Technical Note

To	Environment Agency Permitting Support, NPS Sheffield Quadrant 2 99 Parkway Avenue Parkway Business Park Sheffield S9 4WF	Date	16 August 2023
		Our Reference	12417A-10-R04-01
		Application No	EPR/HP3441QA/A001
		Issued By	Adam Clegg (Technical Director)
		Approved By	Andy Collins (Associate Director)

Subject **RESPONSE TO SCHEDULE 5 NOTICE OF REQUEST FOR MORE INFORMATION**

An application for an environmental permit to operate the Medworth Energy from Waste Combined Heat and Power Facility (the 'EfW CHP Facility') was submitted by Medworth CHP Limited (the 'Operator') to the Environment Agency ('EA') on 4 August 2022. As part of the determination of this application, the EA has requested further information by letter dated 20 July 2023. This note has been prepared to provide a response to the Schedule 5 further information request from the EA.

SO₂ (15-minute mean) contour

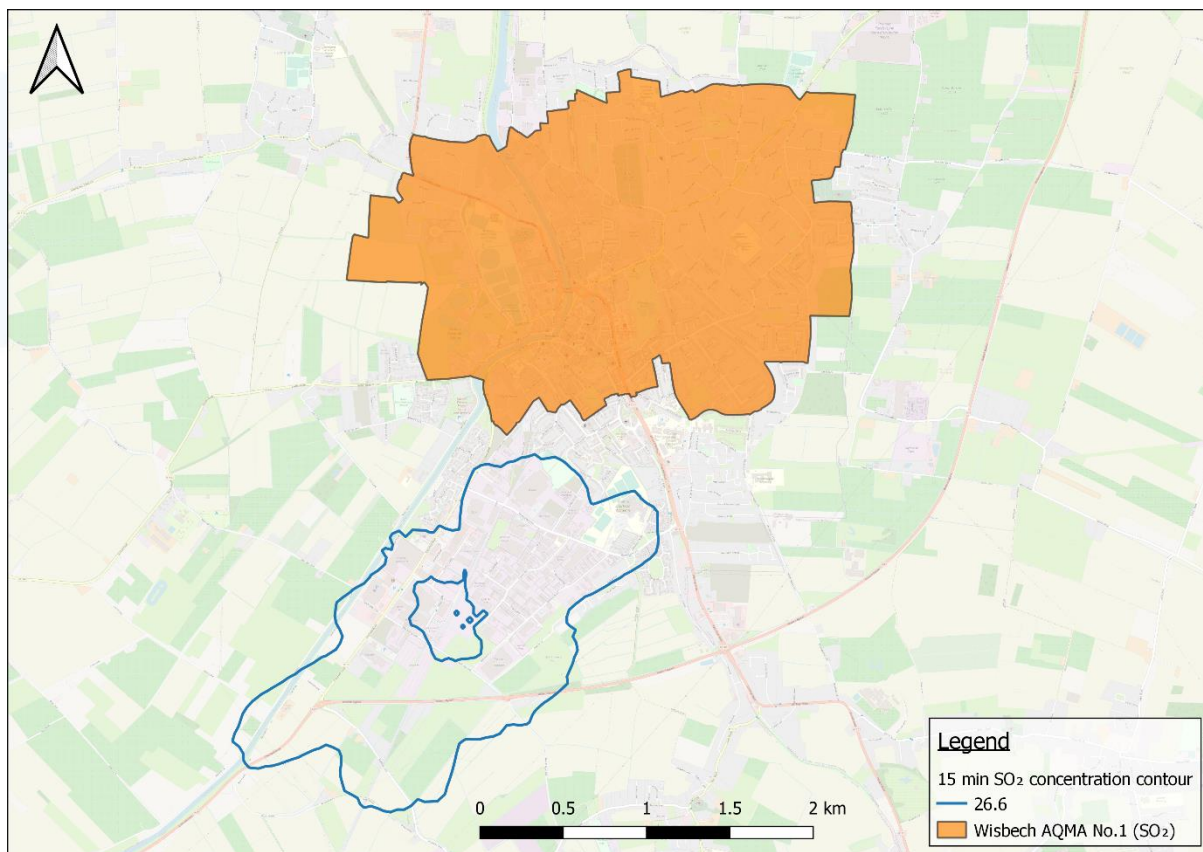
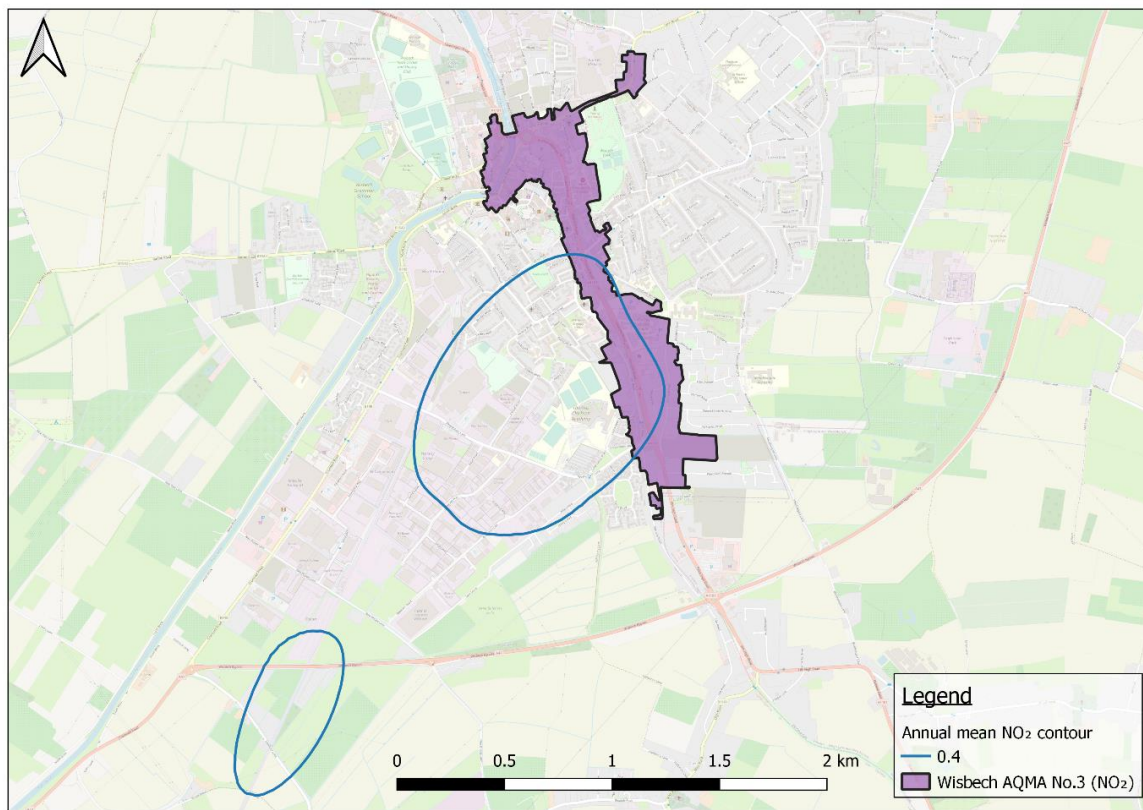
3. Provide three new contour plots to show the PC (as % of EAL) for sulphur dioxide (SO₂) (15-minute mean), PM₁₀ (24-hour mean) and nitrogen dioxide (NO₂) (annual mean). For each contour plot, include the location of the corresponding Wisbech Air Quality Management Area (AQMA), to clearly demonstrate if the PC is predicted to be above or below 1% of the ES for each AQMA.

Response: Concentration isopleths are provided below which depict the ground level process contributions of SO₂, NO₂ and PM₁₀ in units of µg/m³. For 15-minute mean process contributions (PC), a concentration isopleth representing 10% of the air quality objective has been shown, since this is the relevant screening criterion for short-term PCs. No locations within the model domain exceeded 1% of the PM₁₀ air quality objective (i.e., 0.5 µg/m³) and the concentration isopleth levels have been developed to allow visualisation of the plume footprint only.
